RECALL CAMPAIGN NO. 41
Ferrari 360 Modena, Spider & Challenge Stradale
“Hydraulic Steering Delivery Pipe”
RECALL CAMPAIGN OVERVIEW

RECALL CAMPAIGN NO. 41

**Ferrari 360 Modenas, 360 Modenas F1, 360 Spiders,
360 Spiders F1 & 360 Challenge Stradales**

“Hydraulic Steering Delivery Pipe from Pump to Rack”

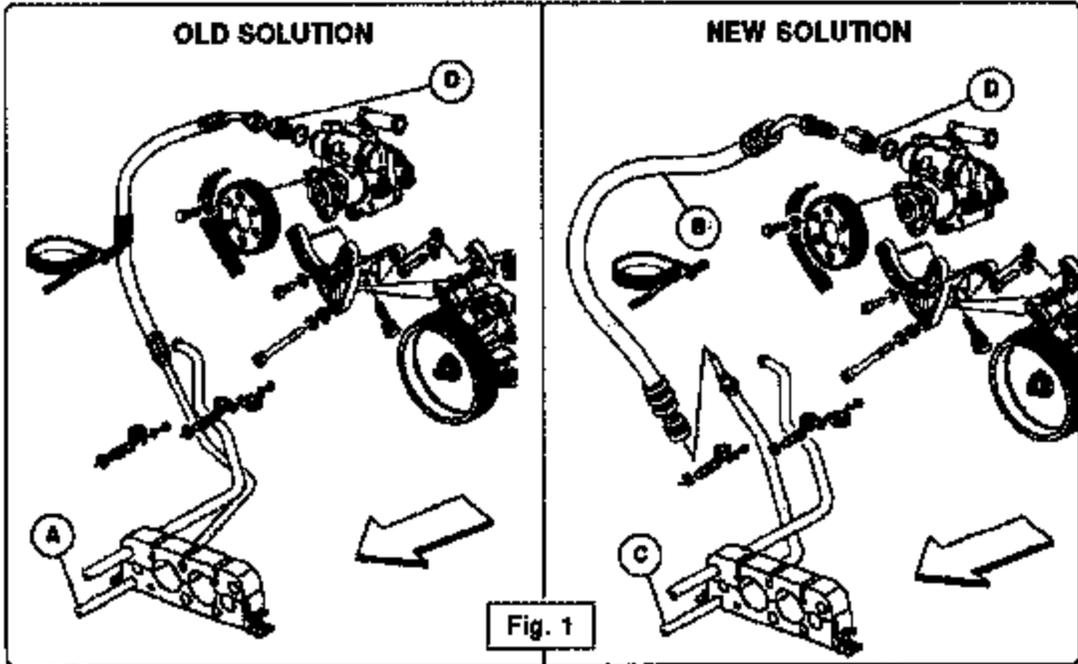
The new design proposes the splitting of the hydraulic steering delivery pipe which runs from the pump to the steering rack (part A in the old design, Fig. 1) into two parts:

- Part B (new solution, Fig. 1) made of a hosing, which runs from the pump to the under-floor C.
- Part C (new solution, Fig. 1) made of a rigid piping, which runs across the entire under-floor.

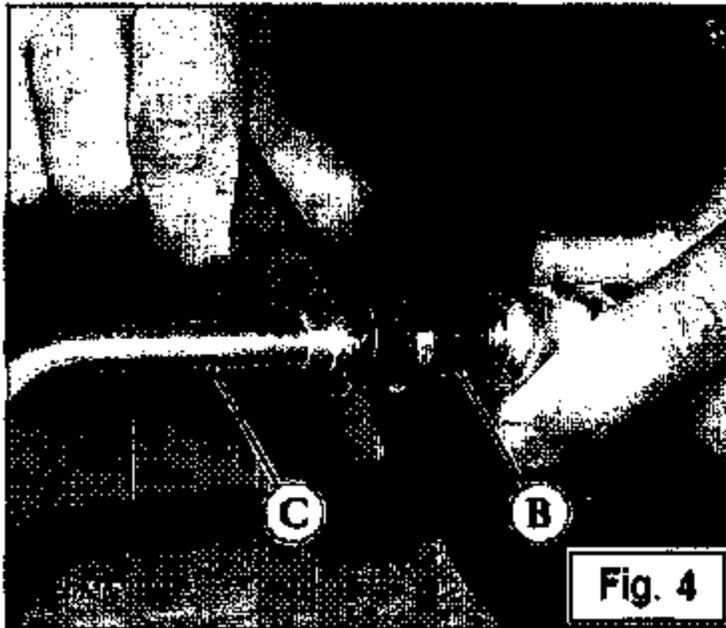
In addition to the pipe in question, the union (D), which has a female section housing the male section of the pipe (B), will also be replaced (Fig. 2).

The pipe and hose supplied (B and C) can be connected via a quick coupling, which has a male section on the rigid pipe C, and female section with a seal on the hose B (Fig. 3).

In order to separate the two sections of the pipe, you must use tool **AV 6038**, shown in the figure 4. The tool P/N **95976038** can be order from the Parts Department.

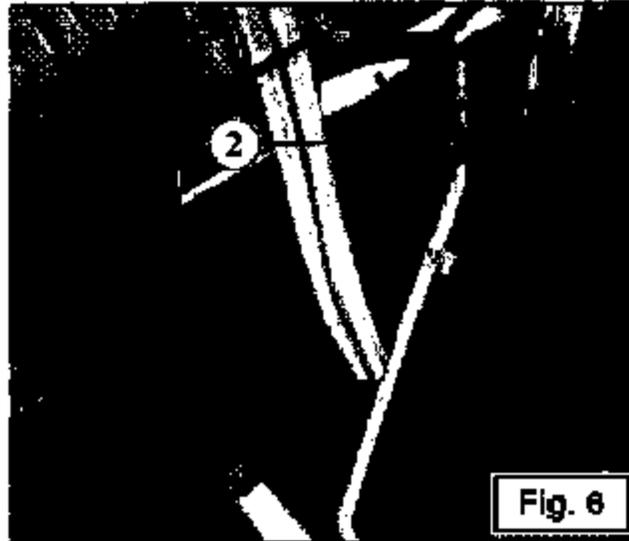
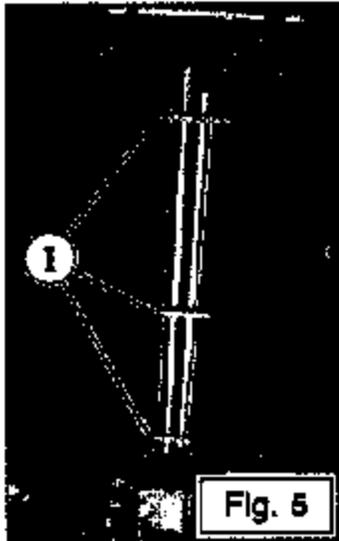
- Remove the rear central and front sections of the under-floor (see **M 2.12** of the service manual).
- Remove the rear movable guard and the waterproof canvas from the luggage compartment as described in section **M 3.06** of the service manual.
- Access to the hydraulic steering delivery pipe union on the pump in the **360 Spider model** is only possible through the engine inspection hatch. Remove the engine inspection hatch following the instructions laid out in section **M 3.05** of the service manual.
- Remove the 3 plates shown as (1) in Figure 5. These plates are in position with the supports retaining the under floor pipes. Please undo the relative fastening screws.

- Detach the sheathed bracket (2) from the bodywork and slide the hydraulic steering delivery pipe (A) (Fig.1) out of the under-floor supports (Fig. 6).

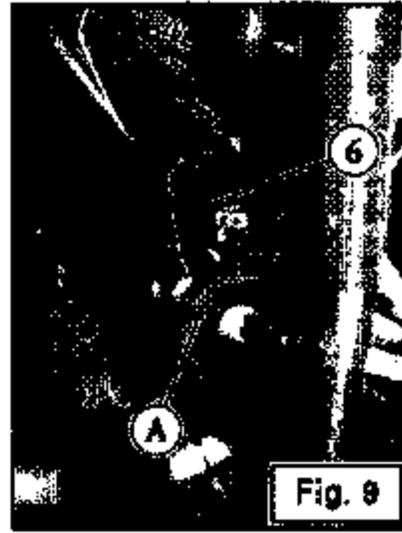
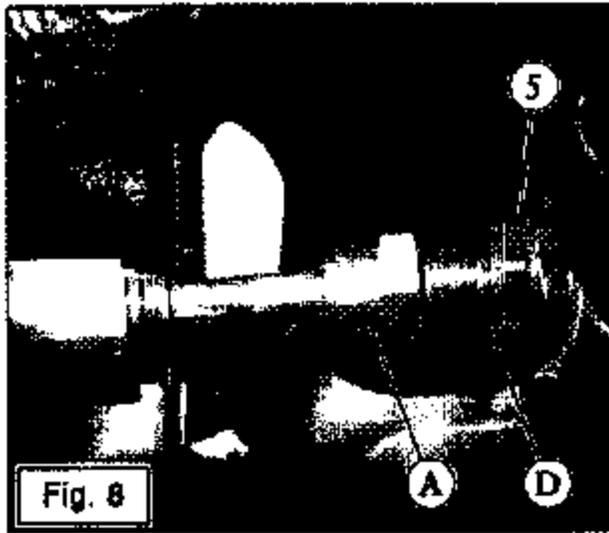
- Fit the new delivery pipe from the jointing to the steering rack (C) into the under-floor supports and refit the 3 original plates (1) (Fig. 10).

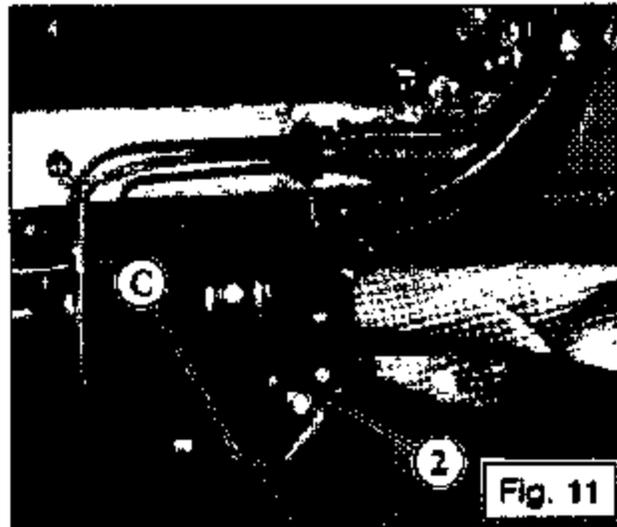
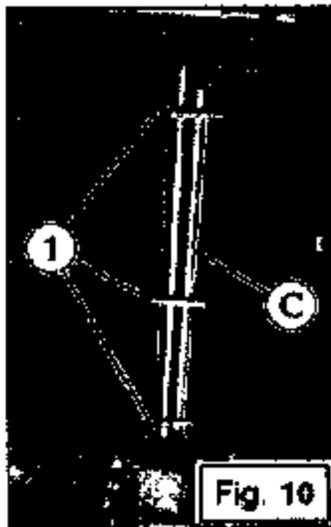
- Fasten the rear end of the pipe (C) to the sheathed bracket (2), removed earlier (Fig.11)

- Fasten the union on the delivery pipe (C) onto the steering rack, positioning it as shown in the figure and tightening it to a torque of 35 Nm (Fig. 11).

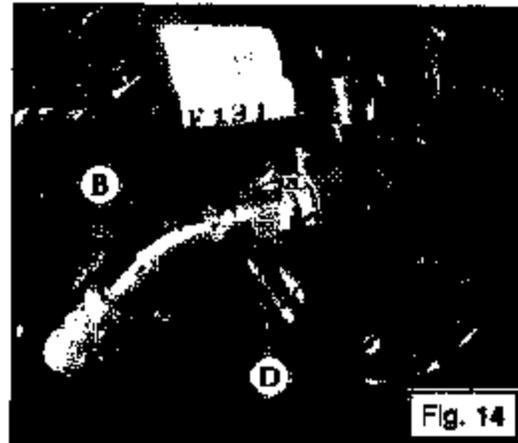
- Lock the union (D) on the pump to a torque of 40 Nm (Fig. 13).
 - Fit the new delivery pipe leading from the pump to the jointing (B) on the union (D) and position it in a way that the pipe is in a vertical position (Fig. 14).

- Lock the pipe (B) on the union (D) to a torque of 35 Nm, contrasting it with the union (Fig. 15).

NOTE: The pipe (B) can be locked only once. Should it need to be unscrewed, it is absolutely essential that the pipe (B) is replaced as it cannot be locked on the union (D) again.

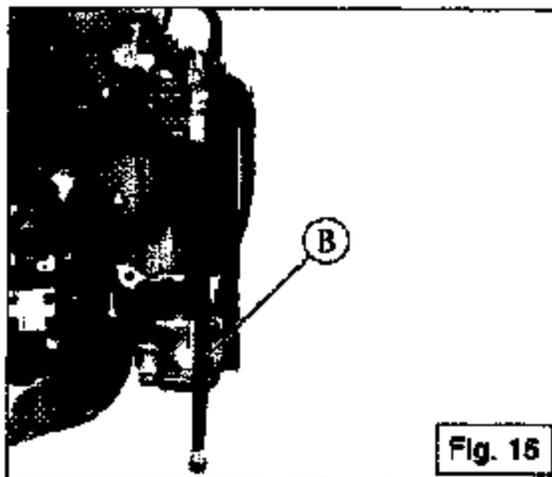
- Fit the pipe (B) into the sheathed bracket (6) and secure the latter on the bodywork (Fig. 16).

- Couple the quick coupling ends of the pipes (B) and (C) (Fig. 16).
- Proceed by refitting the structures removed for the operation, then bleed the system and top the oil up to level, as described in section E 3.02 of the service manual.
